Project:	Lake Geraldine Dam Civil Improvements
RFT #	2022-RFT-028
Addendum #	2
# Of Pages	7
Date:	Tuesday May 17, 2022
Document ID:	P7201-313612880-86(1.0)

The following change(s) in the Tender Documents are effective immediately.
 This Addendum forms part of the Contract Documents.

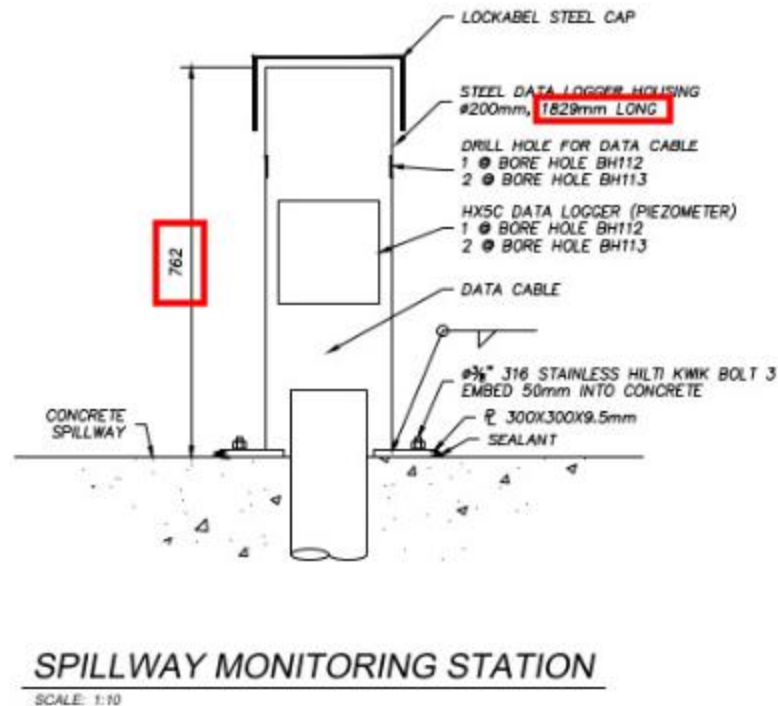
Question: In the typical monitoring station drawing the pile is shown to be inside of concrete. If the pile is installed then filled with concrete to a depth of 1200mm, is the concrete casing necessary?

Response: The “*Typical New Monitoring Station*” detail at the bottom right corner on drawing sheet Fig 1 does not indicate that concrete is to be installed inside the casing, only around the base below grade. The “*Typical Berm Survey Monument Detail*” for the survey monuments (drawing Fig 2) does include concrete around the base and within the steel casing, quantity 5.

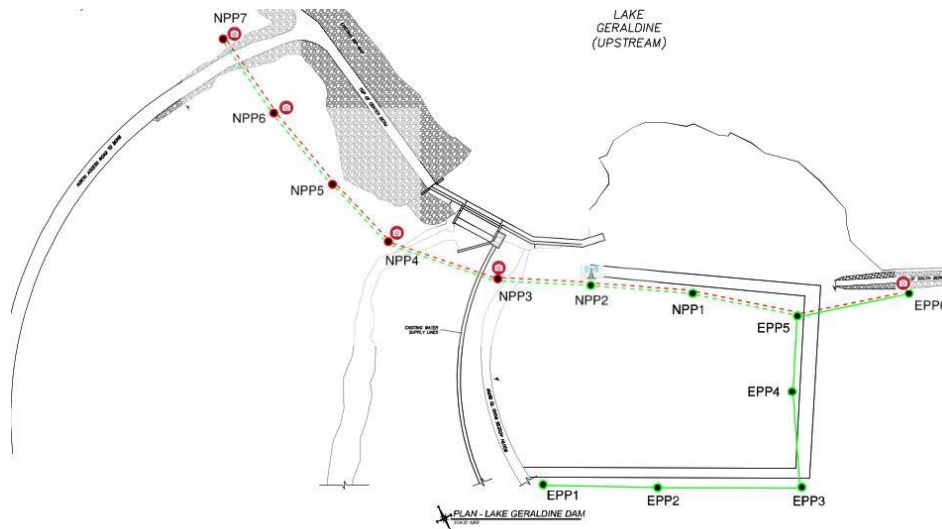
Question: Could you please confirm the diameter of the steel piles for the survey monuments? Section 31 16 00 point 2.1.1 is indicating 8 inch and point 2.1.2.2 is indicating 146mm. Also, the quantity should be changer for eight (8).

Response: Exact casing size can be adjusted to reflect stock available in Iqaluit at time of construction, minimum casing diameter is 140 mm. Total number of survey monument with steel casings is 5, please note that there are three survey monuments to be installed atop the concrete dam, these do not require steel casings.

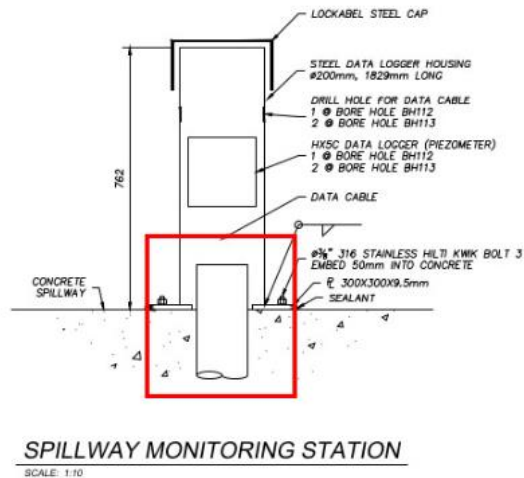
Question: The detail below shows the design for the monitoring stations on the dam. BH112 and BH113 are on the spillway. From the images below, please provide information on the item in red as this item is not seen in the spill way image provided.

Response: Borehole number B112 and 113 are located at the base of the spillway. Canadrill previously drilled the boreholes the boreholes in 2019 and installed the tubes for the piezometers. See photo 16A and 16B. The item circled in red is the portion of the tubes that extend above the surface of the spillway.
